LASER INTERFEROMETER GRAVITATIONAL WAVE OBSERVATORY

LIGO-T1200551-v2

## Optical-lever installation interferences at LHO

**Figure 9: Viewport configuration for ITMY. We are only concerned with ITMY, not FITMY, and thus restrict our attention to VP4 and VP1.**

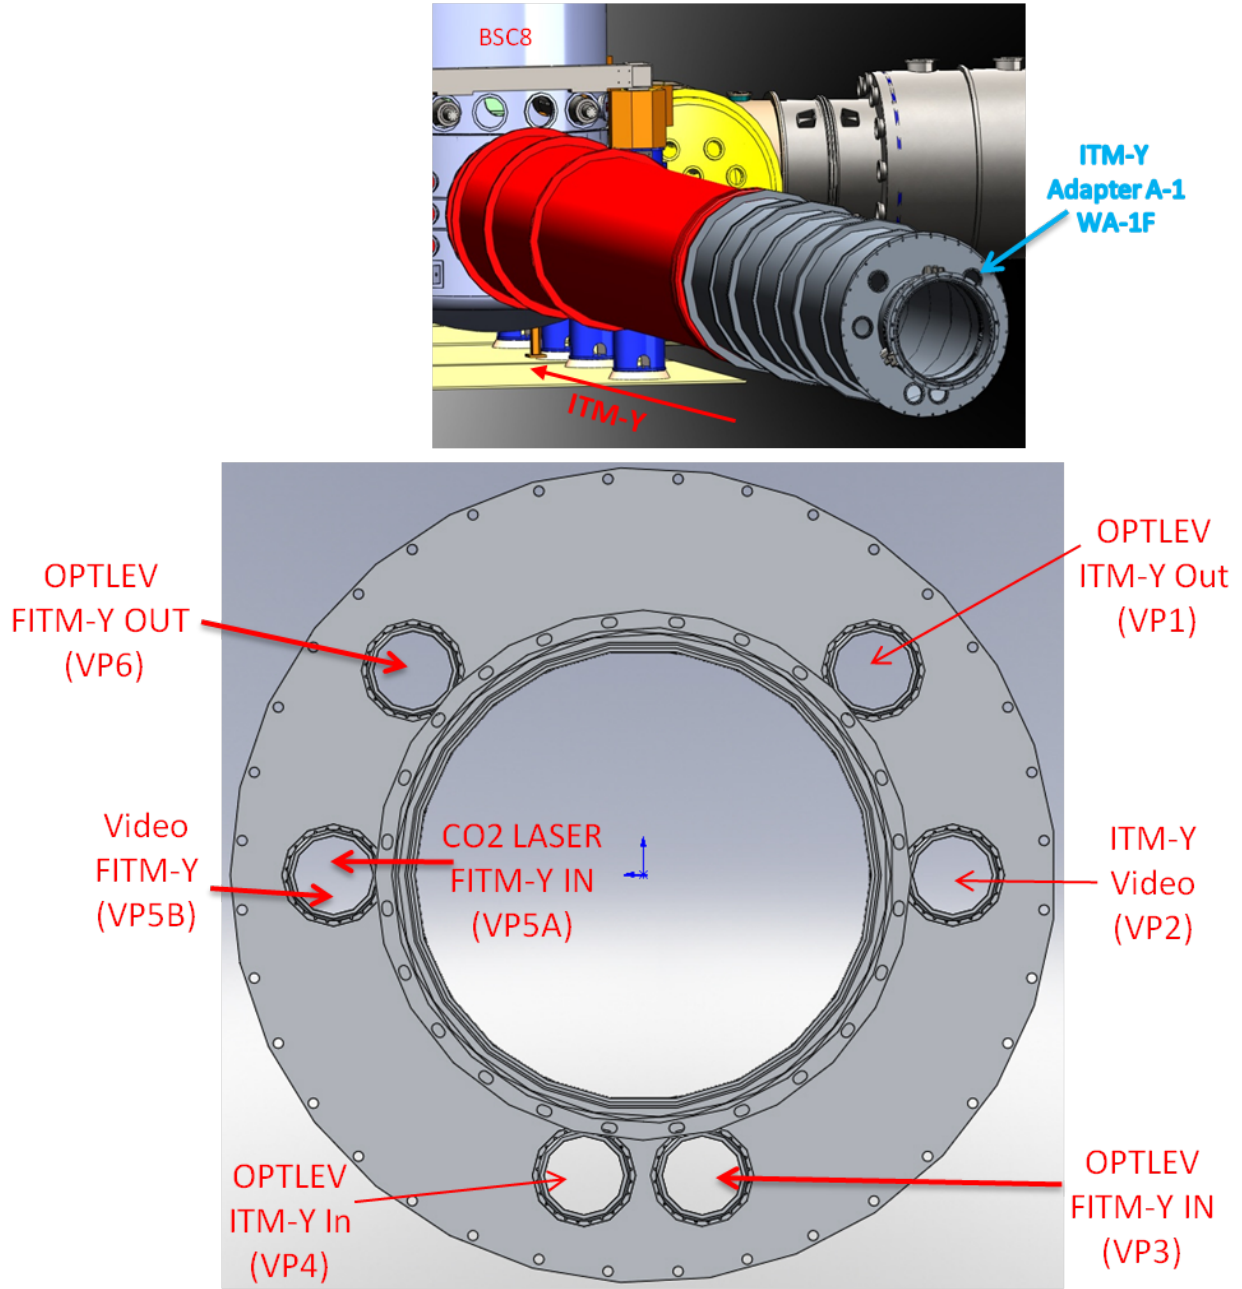
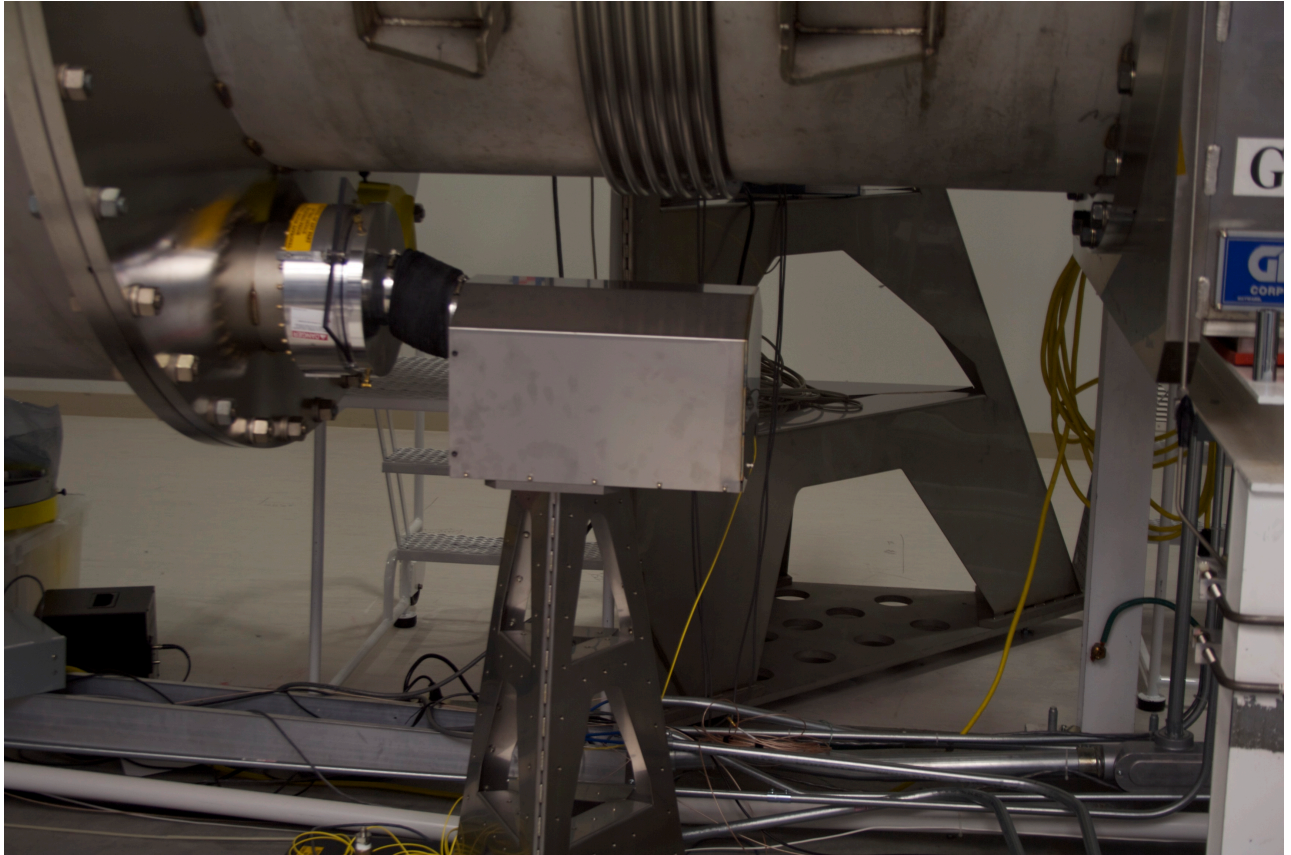
Notes: Installed, but occludes initial-alignment monuments LV17, LV18, and LV19.

Recommendation: Mount initial-alignment monuments on pylon baseplates. Adjust pylon positions along beam axis and rotate transmitter by  $180^\circ$  as necessary.

**Figure 13: Turbo pumping station on AUX cart, where the ETMX leaner should go.**

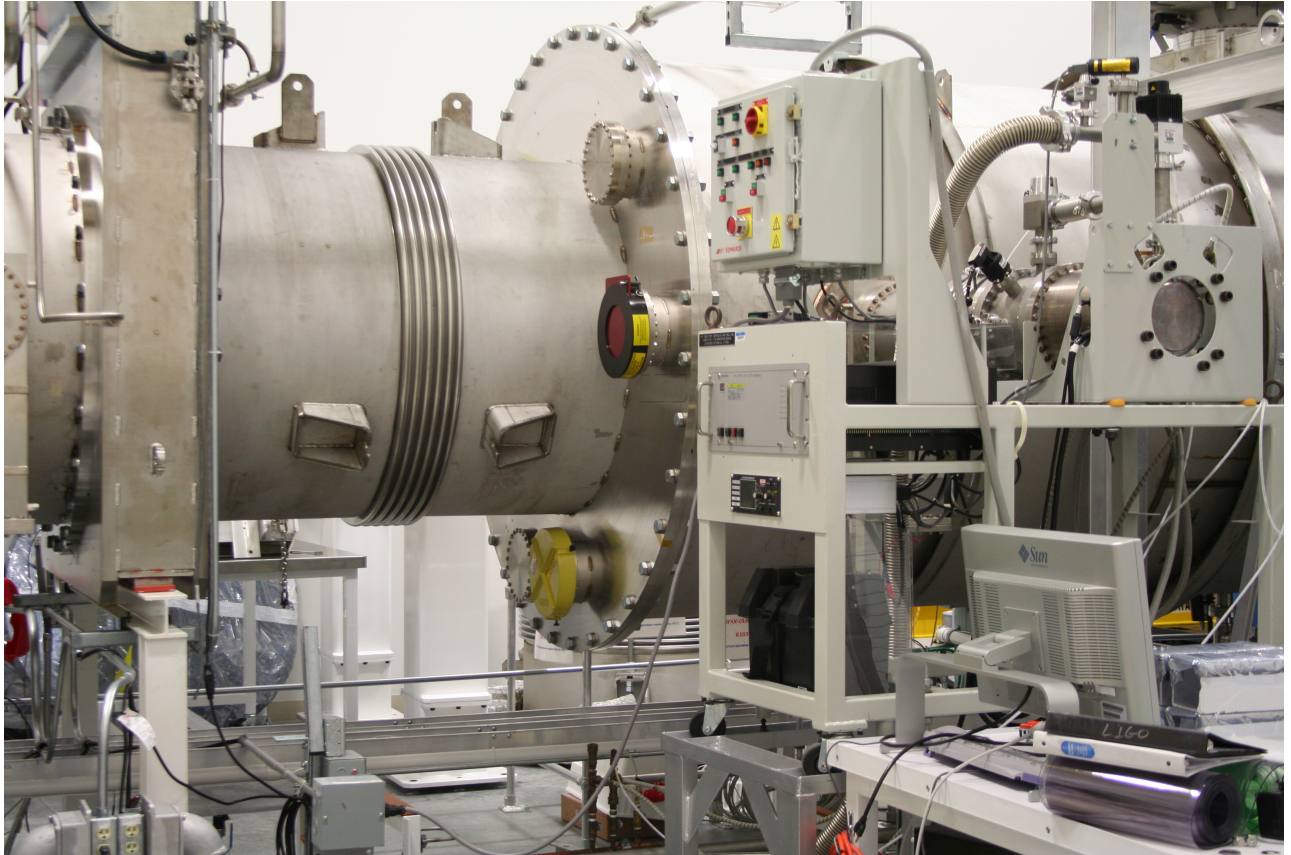
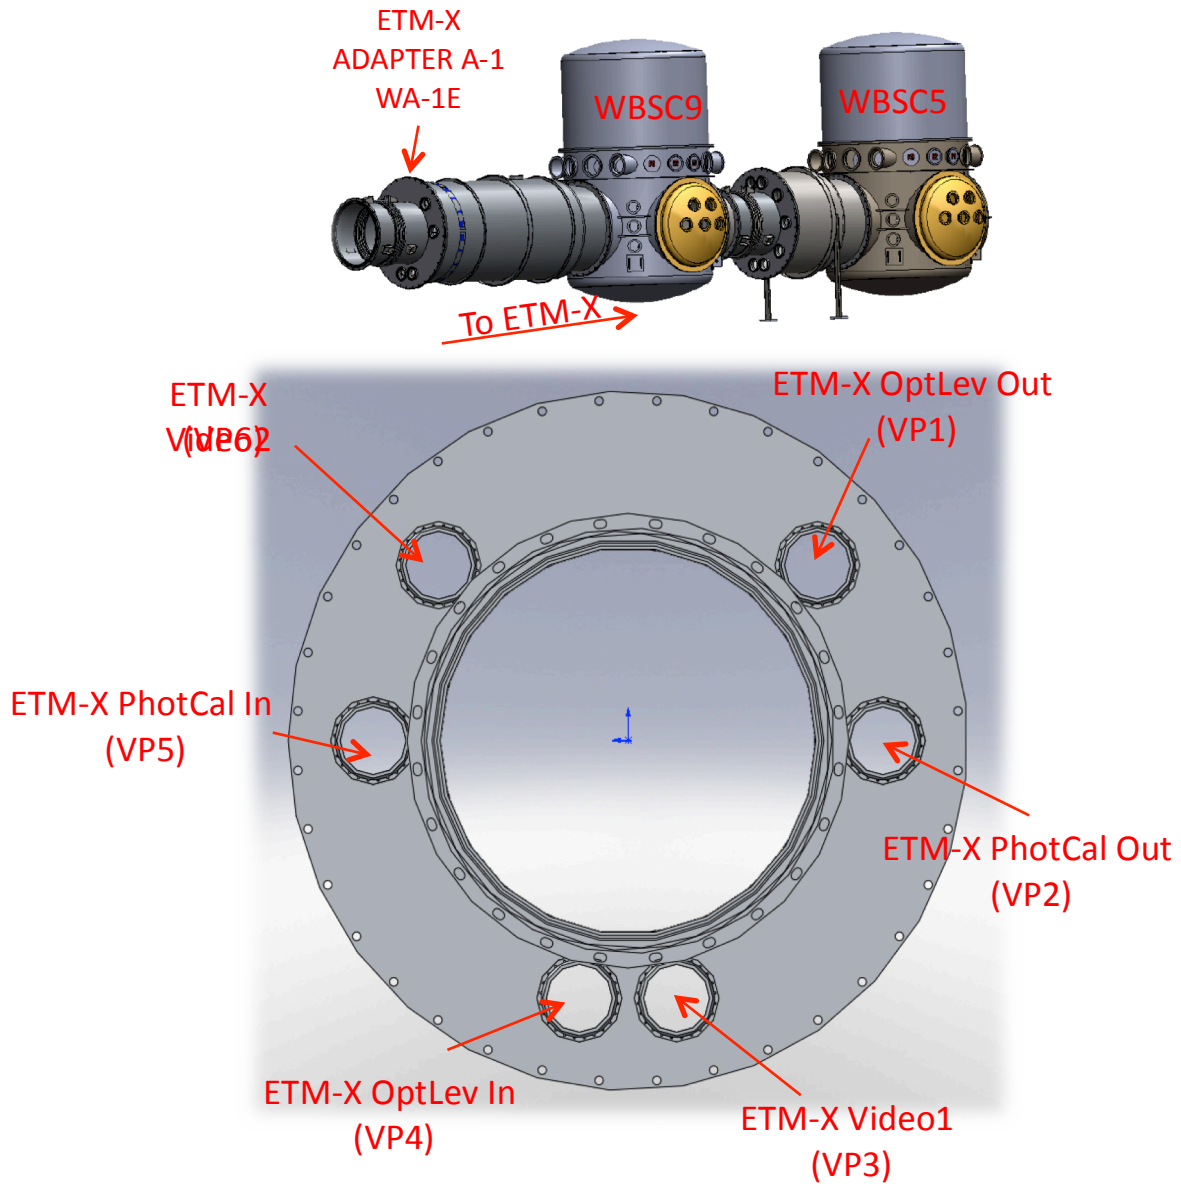
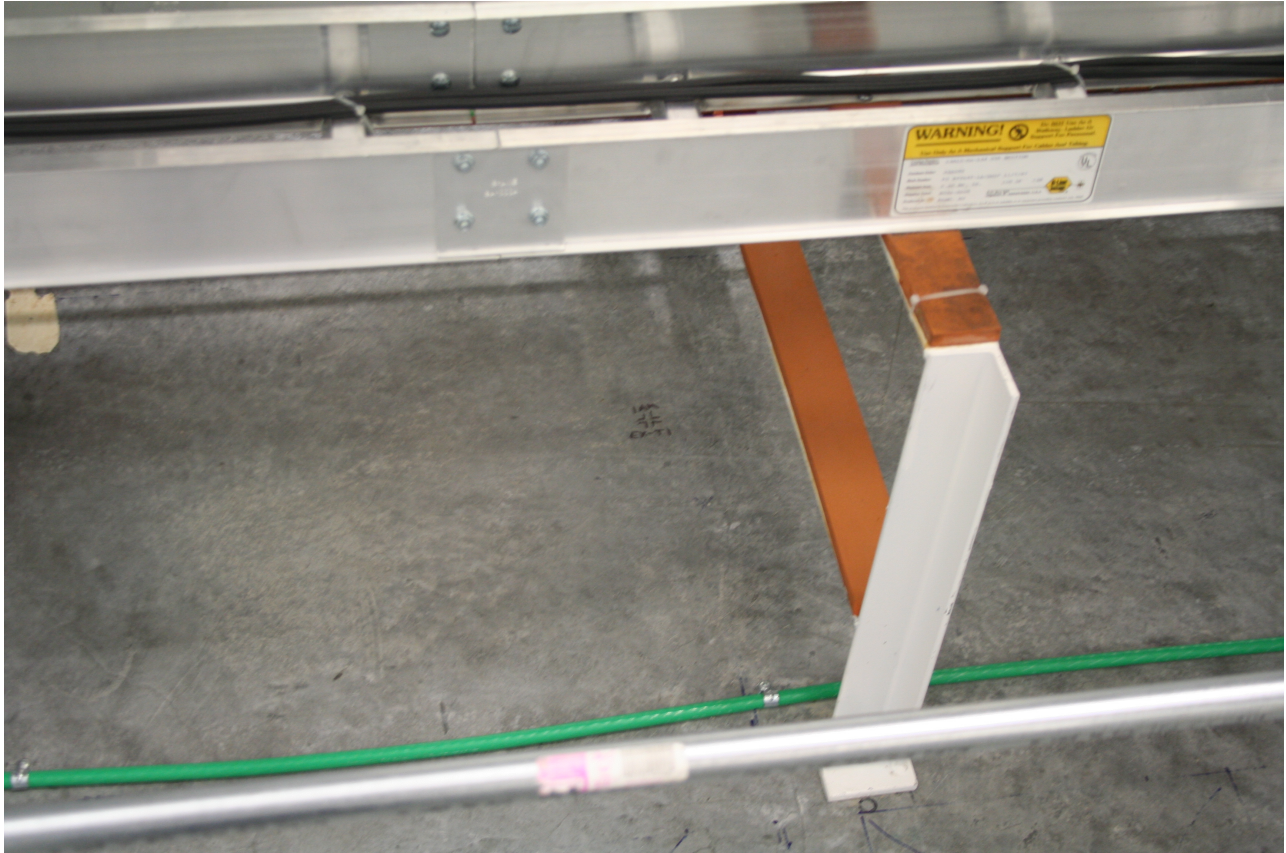
Notes: Significant interference here for both the transmitter and receiver. There is a turbo pump in the way of the leaner, and the dwarf will probably occlude a survey monument used for initial alignment.

Recommendation: Re-position AUX cart to clear space for leaner. Translate launching pylon back ~3.5" and mount monument inside baseplate.
